Site Audit Report and Site Audit Statement for the Remedial Action Plan, Hydro Aluminium Kurri Kurri Smelter Site Audit

Part B2 - Appropriateness of RAP for Smelter Area

06-Jul-2018

Figure 13 Fluoride concentrations in groundwater

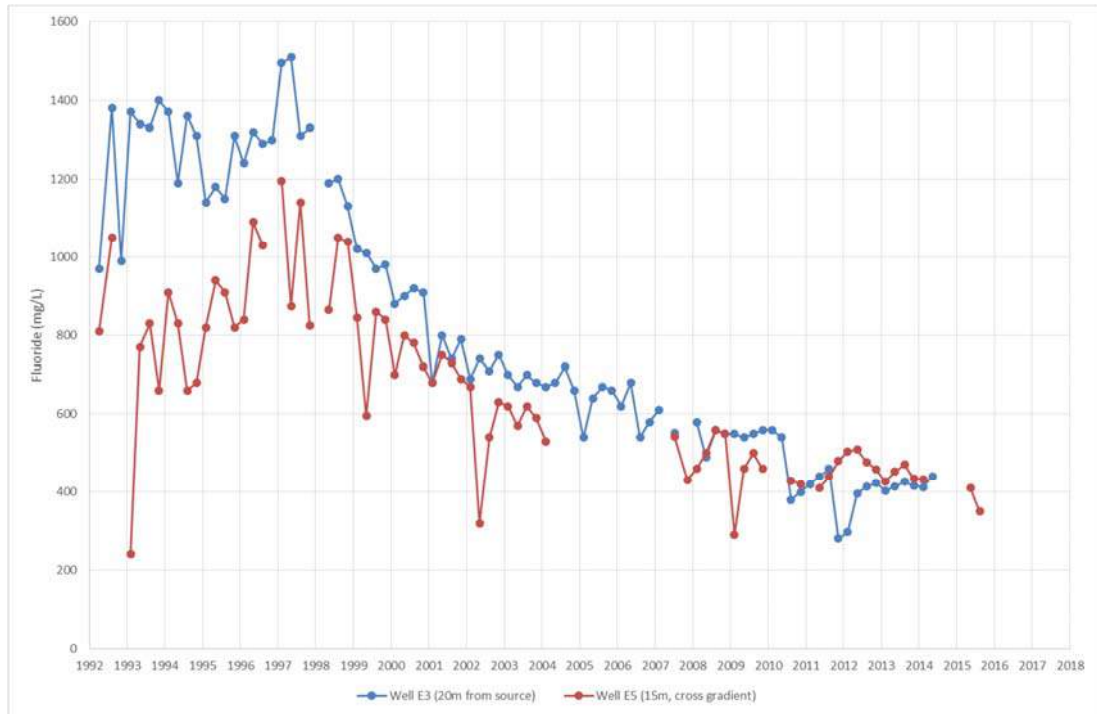
The Consultant reported that the leachate from the Capped Waste Stockpile was impacting on groundwater in a localised area of the Stockpile. **Figure 13** in **Appendix A** shows the Fluoride concentrations at two locations near the Stockpile over time. Results from sampling conducted at the toe of the stockpile, where an active intercepting trench had been constructed, and from sampling in the early 90s by Dames and Moore, were presented in the RAP (included in **Table 6** below).

FIGURE 16
 AS13505

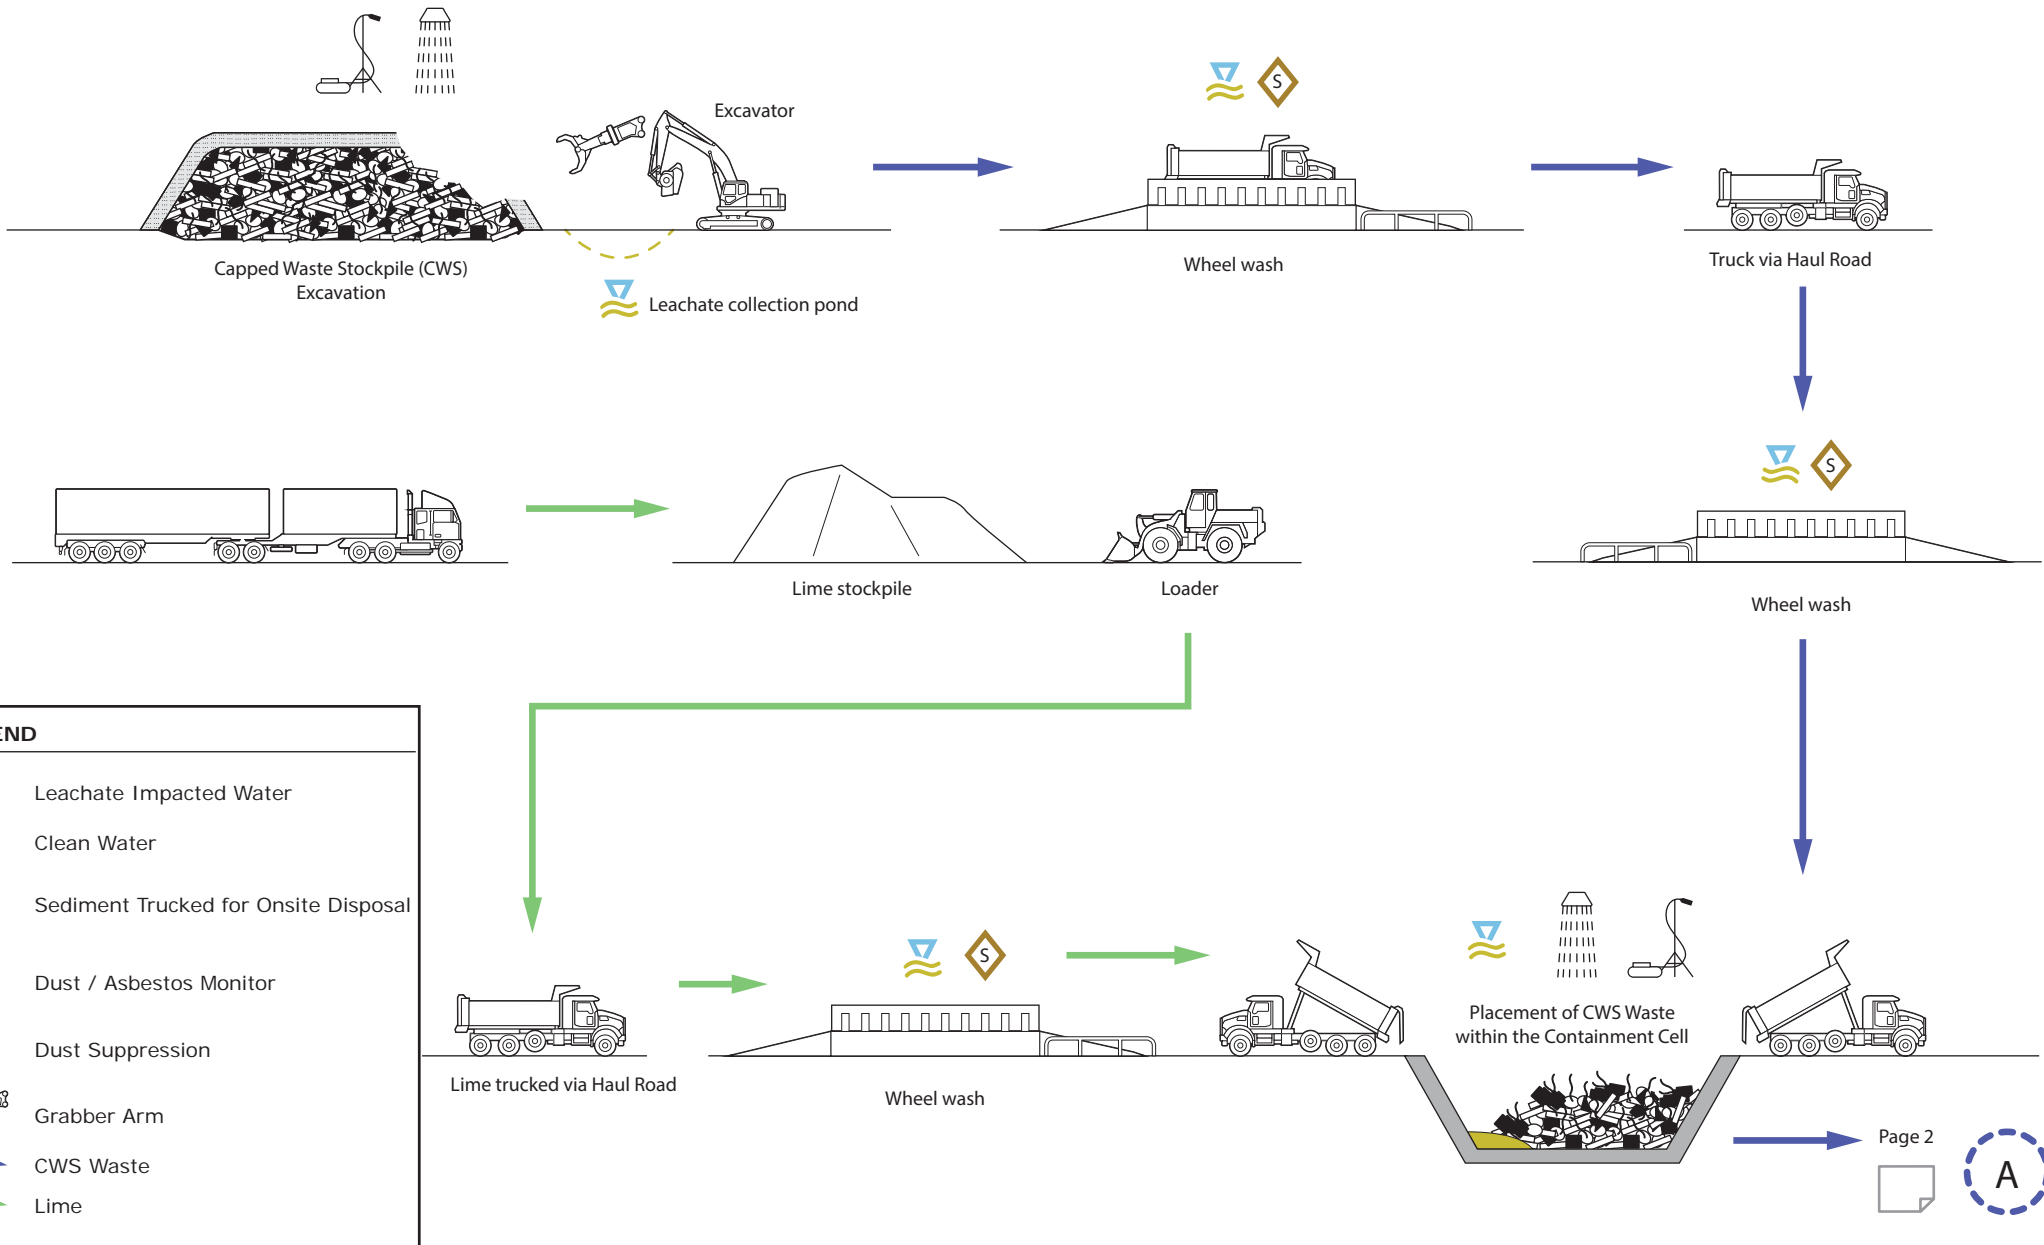
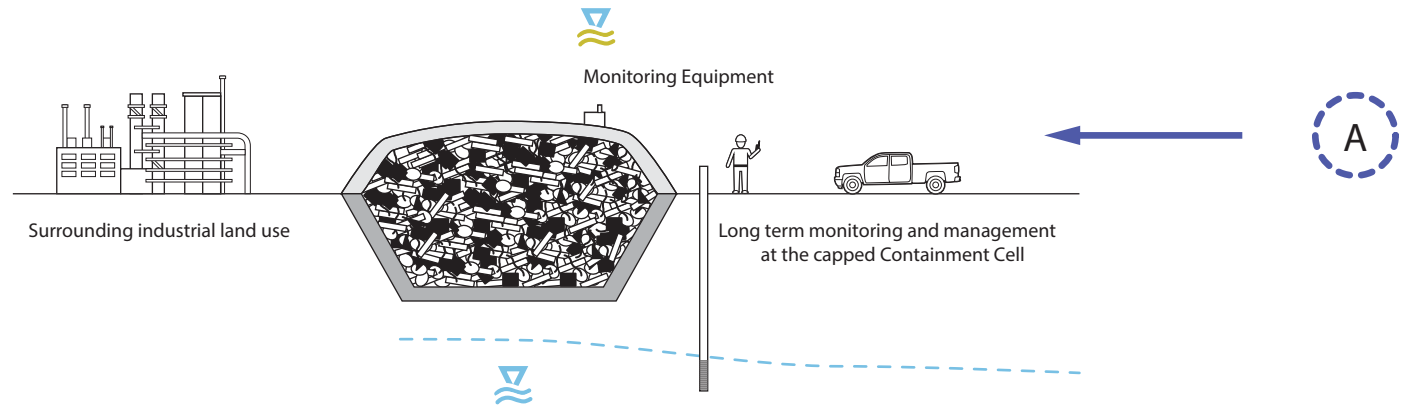
The Consultant’s preferred option identified for soil remediation is the relocation and consolidation of all contaminated soils and the contents of Capped Waste Stockpile in one specifically designed Containment Cell. The Containment Cell will be constructed at the location of the Clay Borrow Pit. This option involves the excavation of the Capped Waste Stockpile, transportation of excavated material by trucks to be mixed with gypsum, disposal of material in Containment Cell, and capping of material (Ramboll Environ, 2016f). This proposed remediation methodology is shown in **Figure 16** in **Appendix A**.
